LARAMIE COUNTY PLANNING & DEVELOPMENT DEPARTMENT

MEMORANDUM

TITLE: PUBLIC HEARING regarding a Subdivision Permit and Plat for Addison

Meadows, located in a portion of the S1/2 SE1/4 Section 33, T.13N., R.62W.,

<u>County Public Works Department:</u> County Public Works Department, 9/01/2021 Molly Bennett

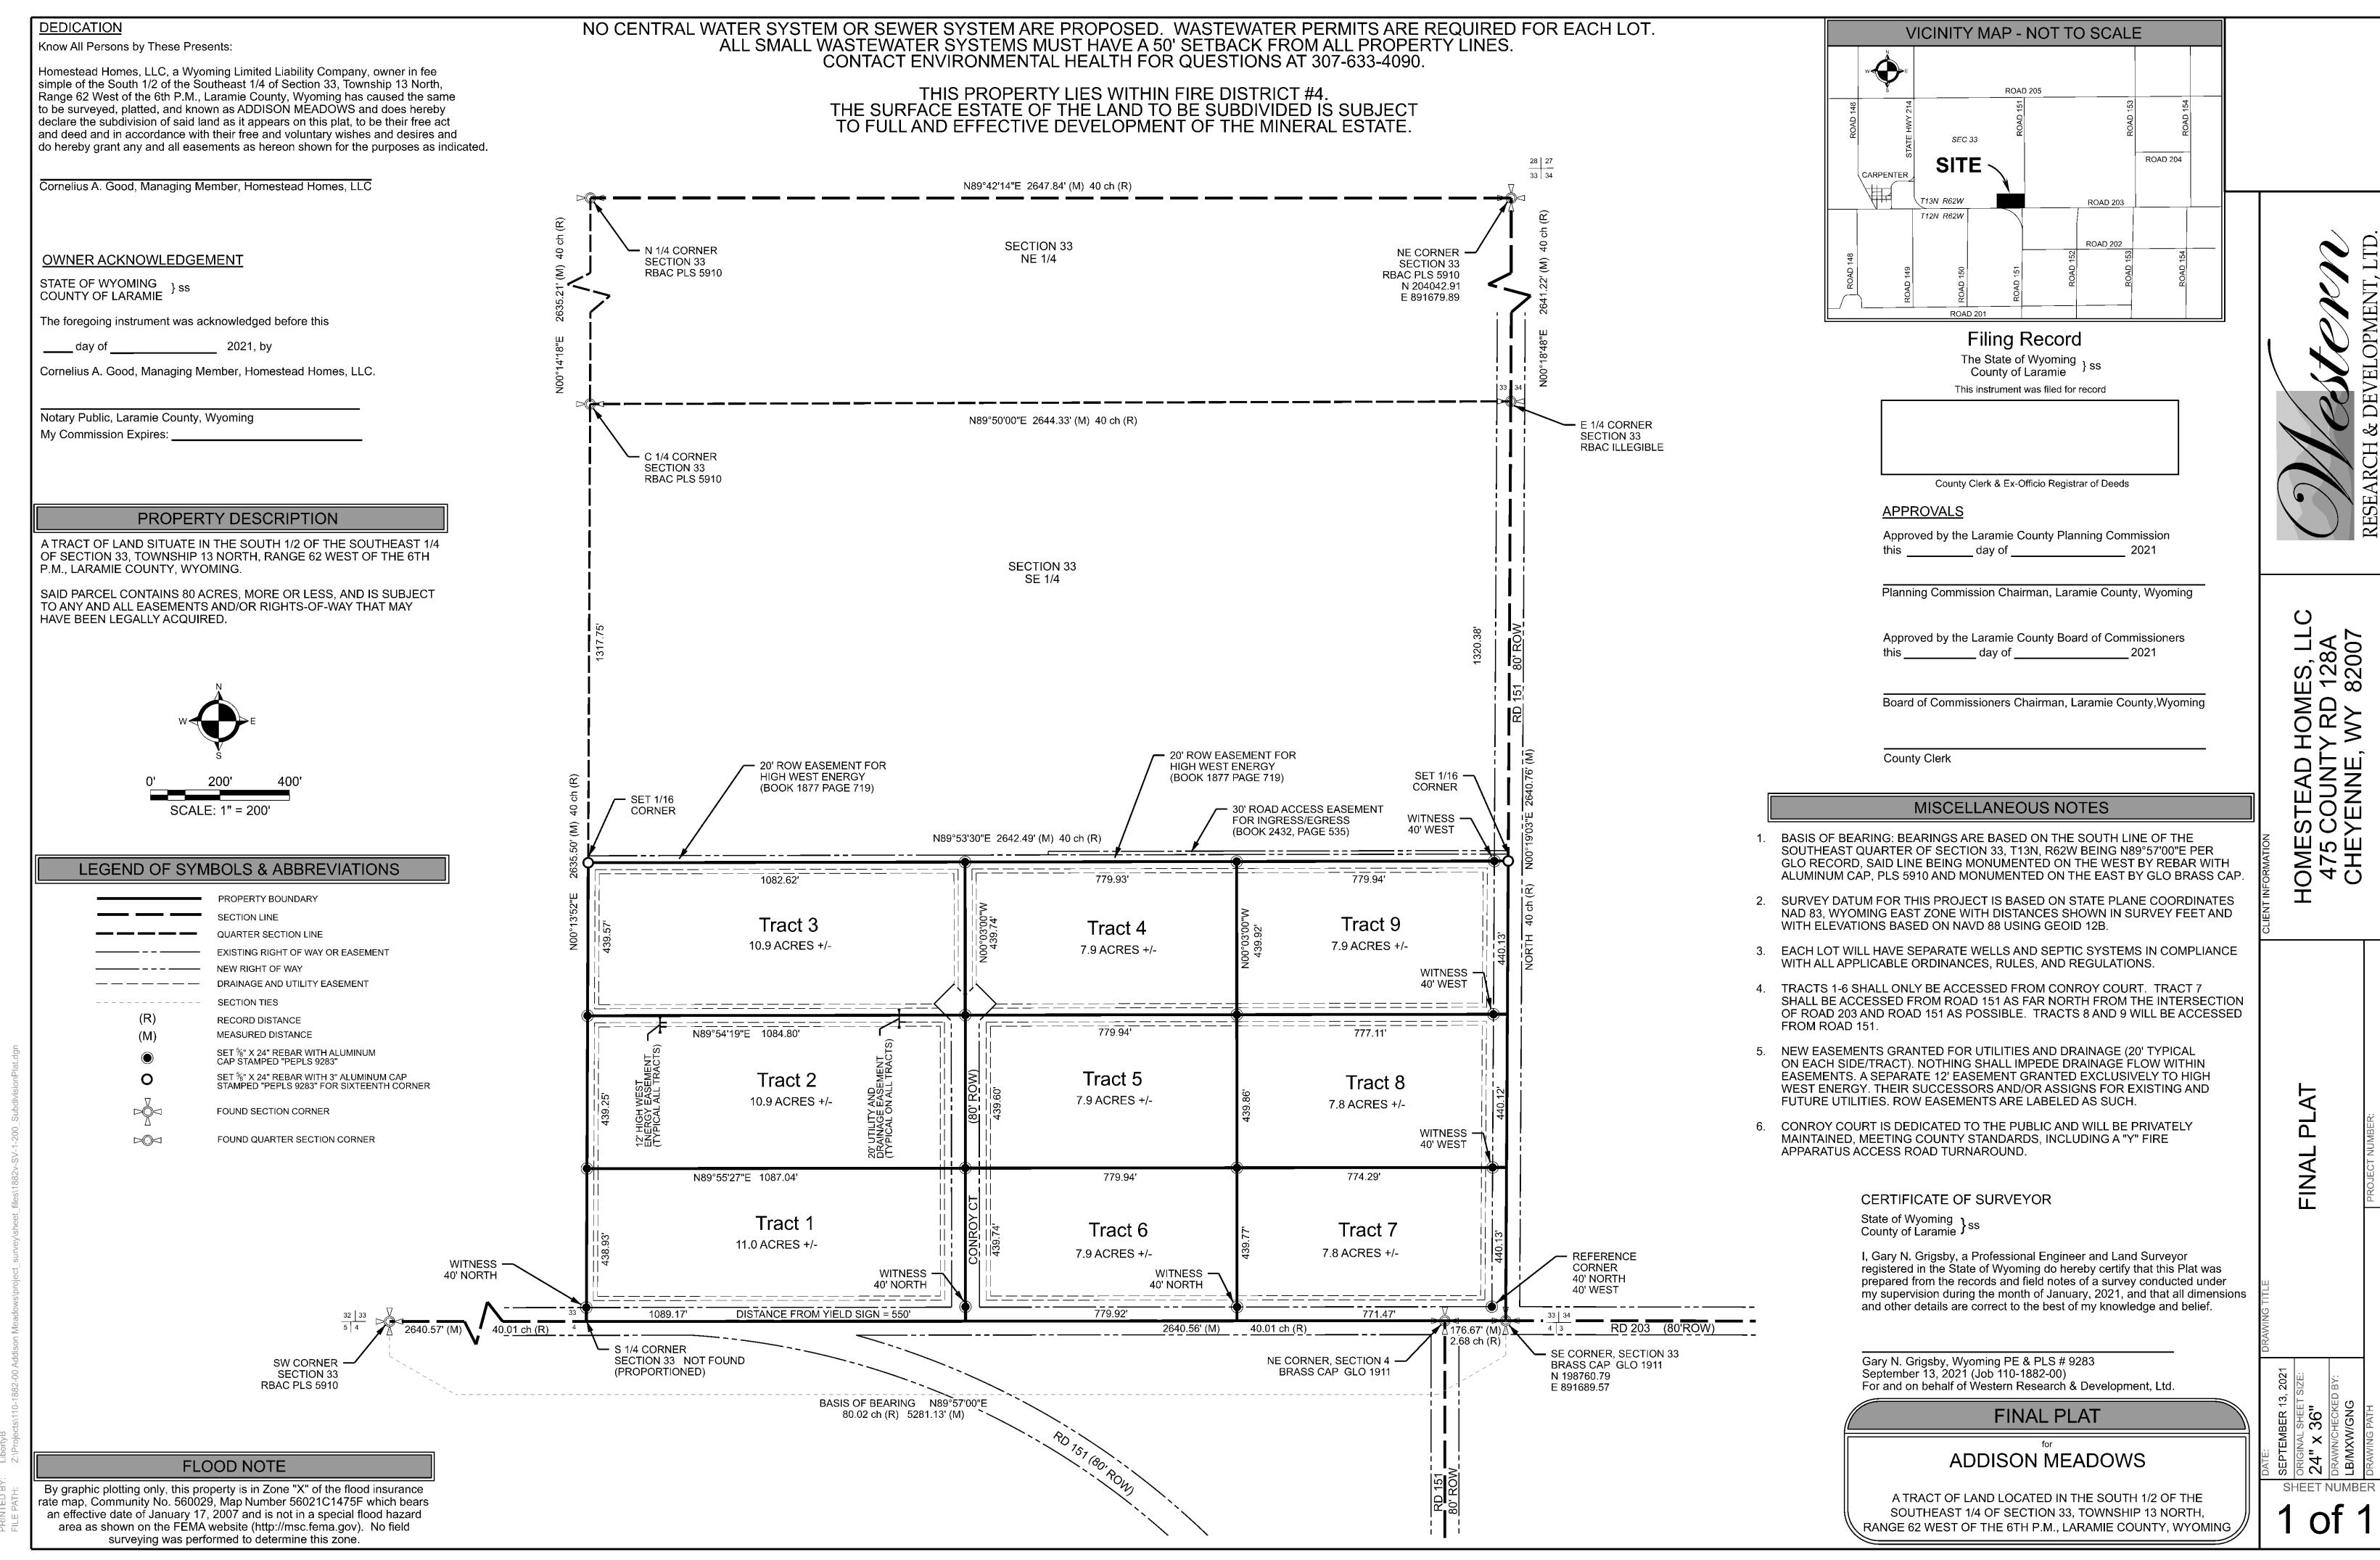
All internal roads or easements shall be built to County Standards. A Right-of-Way and Grading Permit will be required for all road/easements to be constructed.
